This is in response to Public Notice 2004-388-1, an application by Cape Wind Associates for a Section 10 permit to install and maintain 130 wind turbine generators and associated infrastructure in Nantucket Sound, Massachusetts.

**FINAL Department of the Interior Comment/Response Matrix
Cape Wind Associates; Army Corps of Engineers, New England District
Draft Environmental Impact Statement**

Figure 1. Ten-minute squares of latitude and longitude that contain or are adjacent to proposed disturbance site.

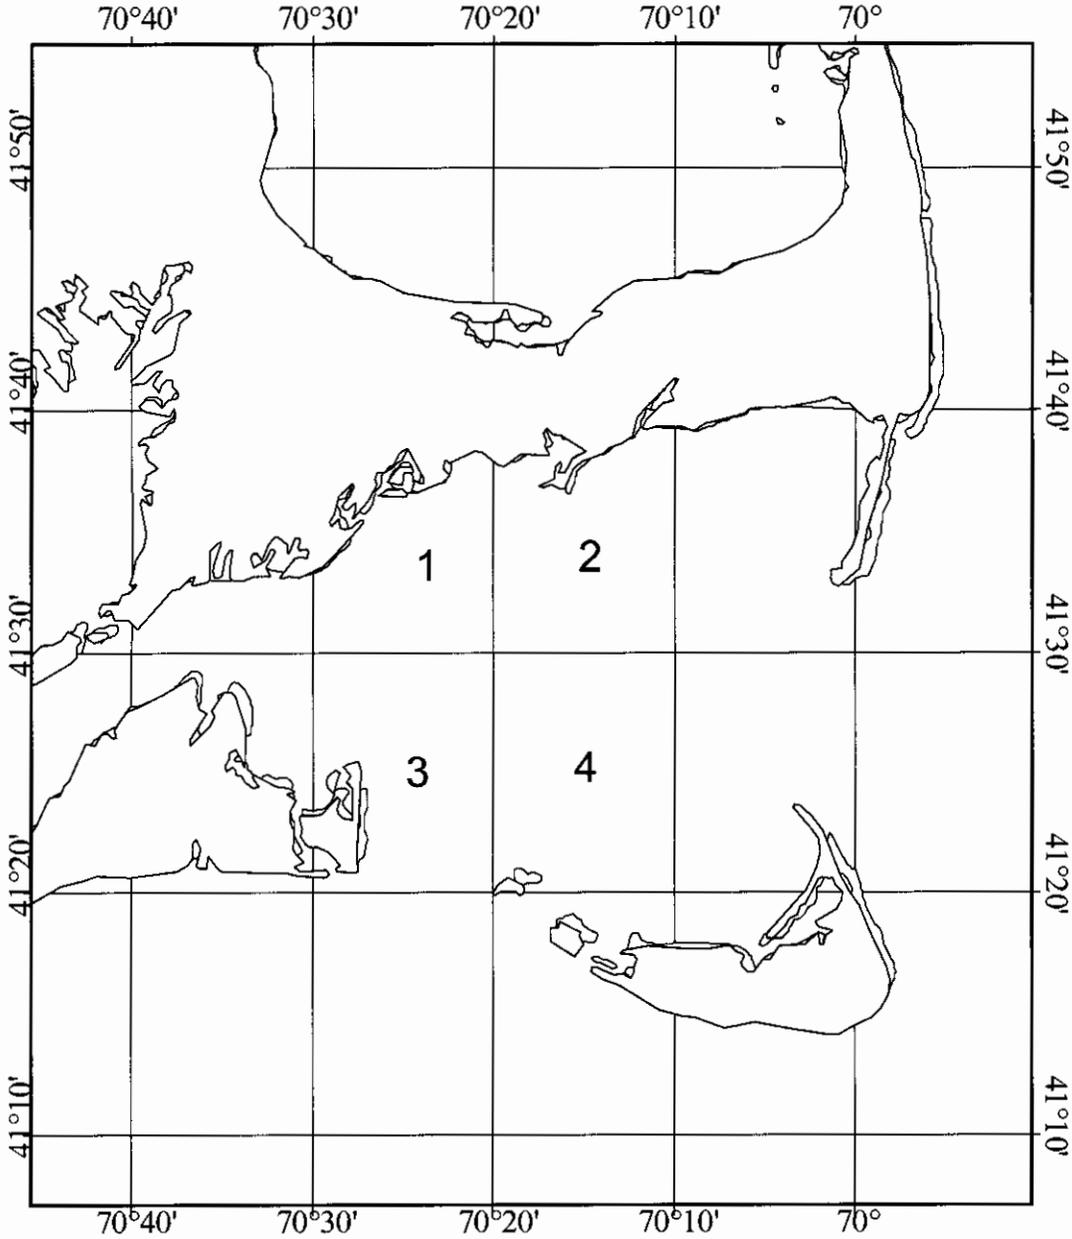
- The map shown in Figure 1 depicts the four ten-minute squares (TMS) of latitude and longitude that overlap with, or are adjacent to, the proposed project area. For each of these TMS, respectively, Table 1 reports the fishing activity from federally permitted vessels. Fishing activity is reported as the number of 24-hour days absent from port by TMS for trawls and dredges and number of trips for fixed gears as compiled by the NMFS for the time period 1995-2001. Not all fishing trips are reported by latitude and longitude and, therefore, some trips cannot be binned into TMS. As a result, the data shown in Table 1 are a large sub-sample (approximately 75-80%) of all trips. Therefore, the numbers reflect the relative, not absolute, amount of fishing activity by gear among these four areas. As you can see the disturbance area is an important area for commercial fishing, between 267 and 749 trips have been logged by fishermen using fixed gears and between 398 and 922 days fished have been logged by fishermen using mobile gear.
